**RESOLUTION HOLDING HEARING ON REQUEST FROM
M & R HOLDINGS, LLC FOR REVIEW AND APPROVAL OF THE 1ST AMENDMENT
TO THE WOODLAWN PUD CONCEPTUAL PLAN FOR PROPERTY LOCATED AT
4209 LOWER BEAVER ROAD**

APPROVAL of a motion to find the proposed reduction in building type variety subject to the following conditions:
(ZON2017-0003)

WOODLAWN 1ST AMENDMENT PLANNED UNIT DEVELOPMENT

WOODLAWN 1ST AMENDMENT PLANNED UNIT DEVELOPMENT

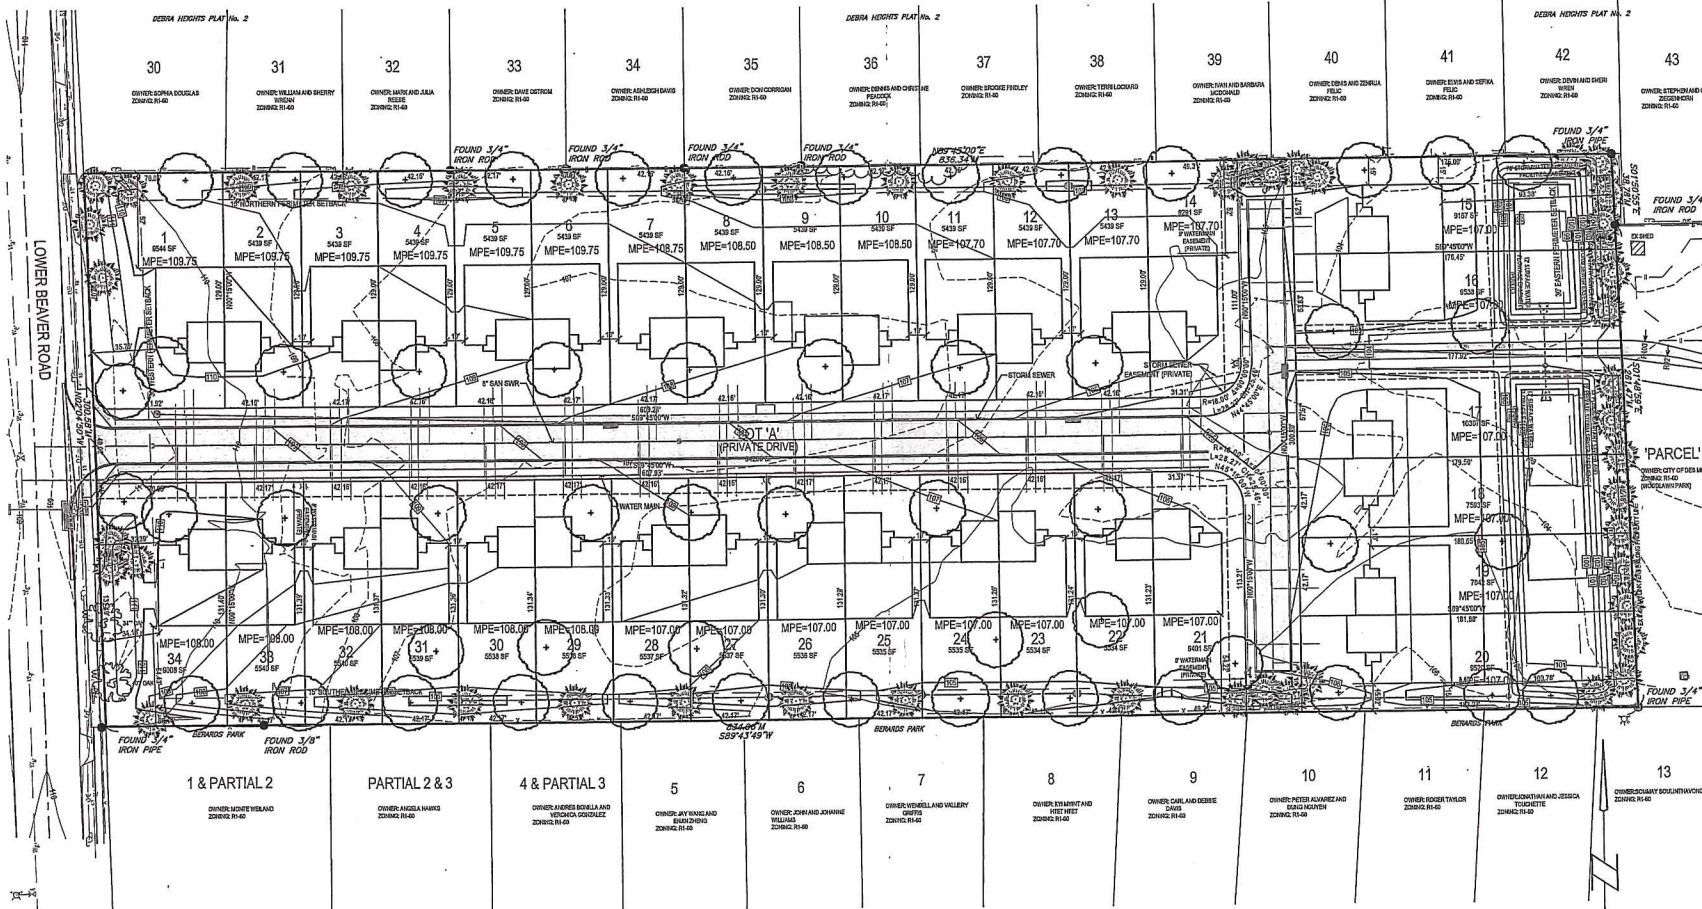
4. **Landscaping & Buffering:** The previously approved and proposed PUD Conceptual Plans indicate a requirement to meet an established Open Space and Bufferyard requirement. This would require 2 over story trees and 2 evergreen trees per 100 feet along the perimeter yards adjoining residential properties as part of any Development Plan. It also required 1 over story tree, one evergreen tree, and one shrub per 2,500 square feet of a minimum 20% of open space. In order to accommodate adjoining neighbor concerns, the developer has concentrated the tree planting concept to the perimeter of the development. The previously approved PUD Conceptual Plan included a 6-foot tall wood privacy fence around the perimeter of the development. The amendment does not propose a privacy fence. Staff would recommend that the plans be revised to include a privacy fence based on previous neighborhood concerns.

The calculations on the submitted landscape concept in the Preliminary Plat/PUD Development Plan are correct under this standard in the PUD Conceptual Plan. However, the submitted Preliminary Plat/PUD Conceptual Plan does not provide planting species detail.

Plans need revision and more detail on many items including perimeter privacy fence, signage, storm water plans.

1. Revision of the Conceptual Plan amendment to provide a 6-foot wooden opaque privacy fence along the north and south property lines.

2. Remove the reference allowing Vinyl in the Architectural Standards, thereby prohibiting it as a permitted material.
3. Add a note to consider provision of separate visitor parking with any Preliminary Plat/PUD Development Plan.
4. Revision of the PUD Conceptual Plan notes to indicate compliance with the Fire Code for provision of secondary access or alternate design approval by the Fire Department.
5. Prior to submission of the PUD Development Plan the developer shall have a neighborhood meeting to review the PUD Development Plan and building plans.
6. No additional driveways on Lower Beaver Road.
7. Provide some enhanced landscaping on Lower Beaver Road frontage.
